Technical Guidance Committee Meeting

Thursday, September 7, 2017

10:00 AM Product Review: Infiltrator ATL Design and Installation Manual

OSCAR Side View

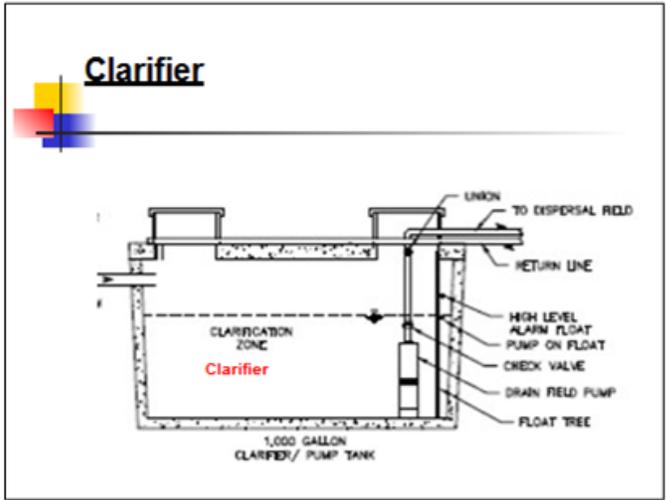
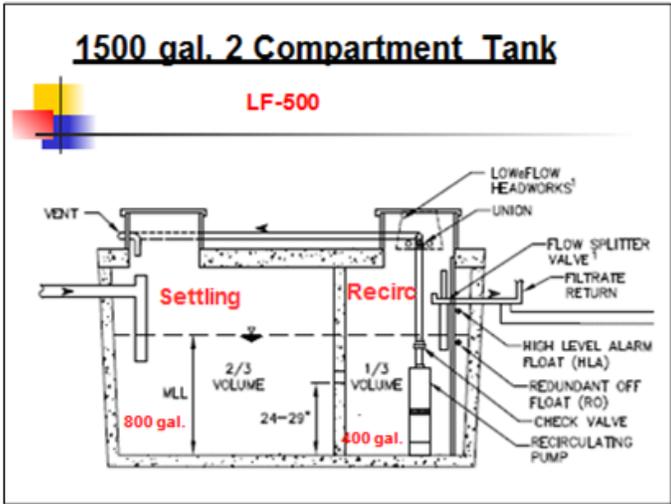
Dave Lowe said, the coil is not elegant but functional, and the bracket is to keep it in its shape.
